LAST REVISION	REVISION	DESCRIPTION:	FDOT	FY 2023-24 STANDARD PLANS	LIGHT POLE PEDESTAL - WALL COPING	INDEX	SHEET
11/01/21						521-650	1 of 3

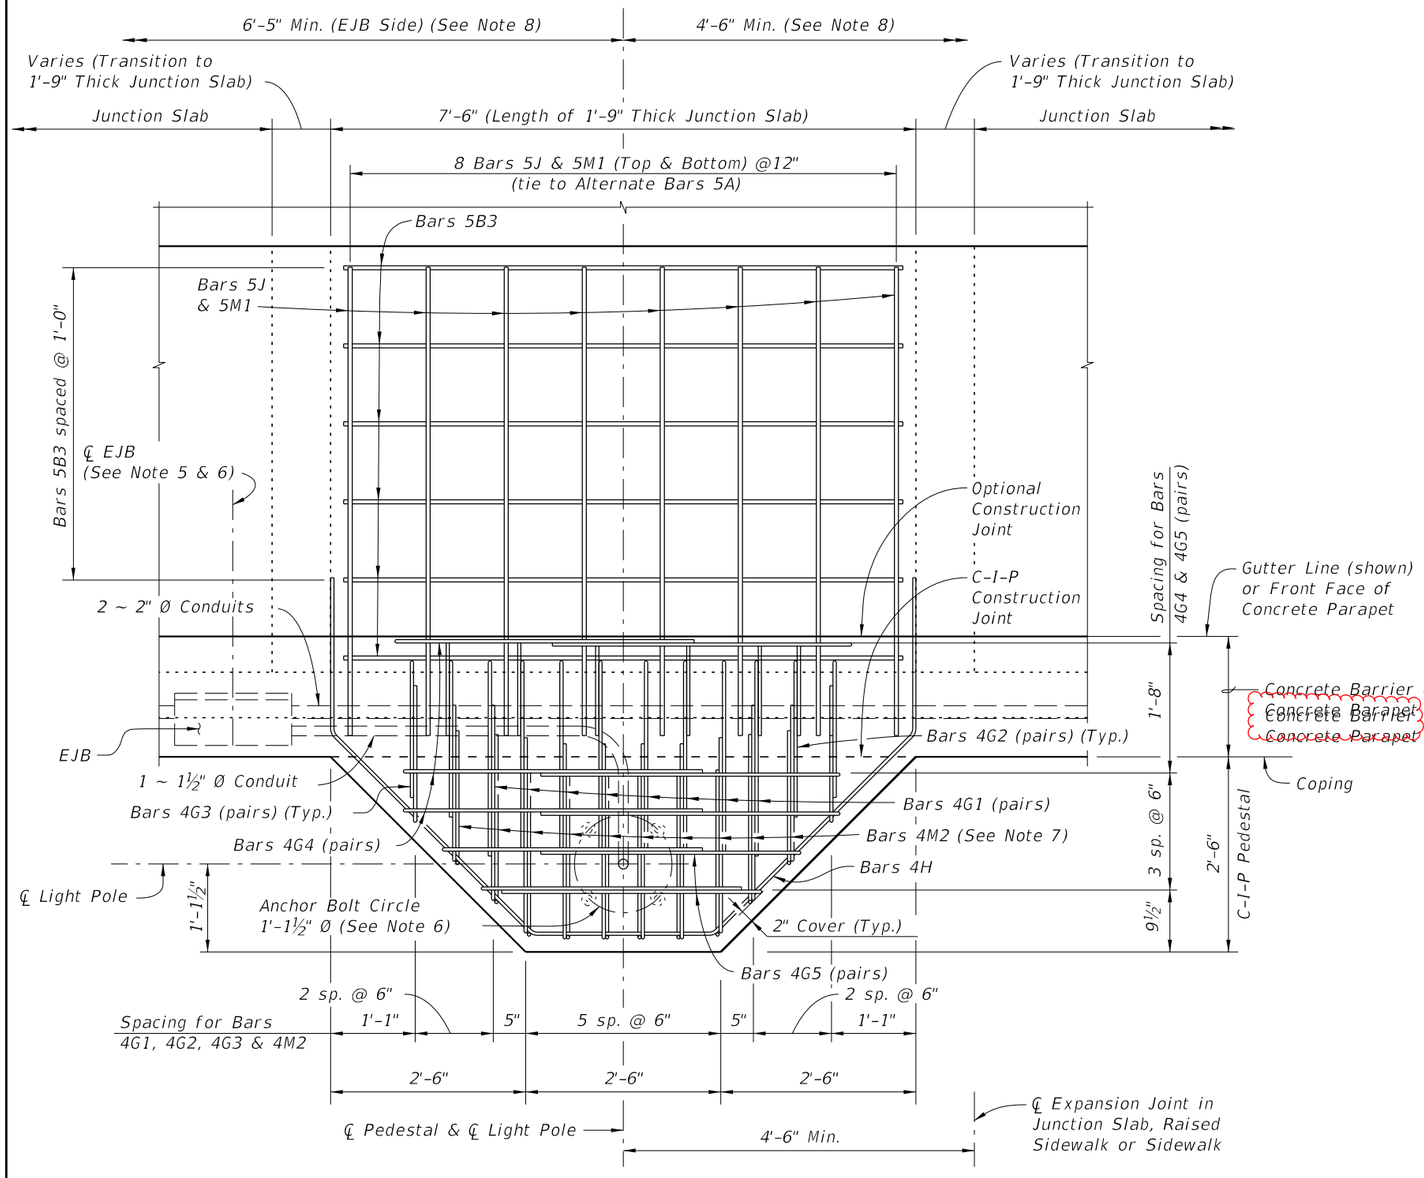
Corrected Callout

Correct asterisk (Double)
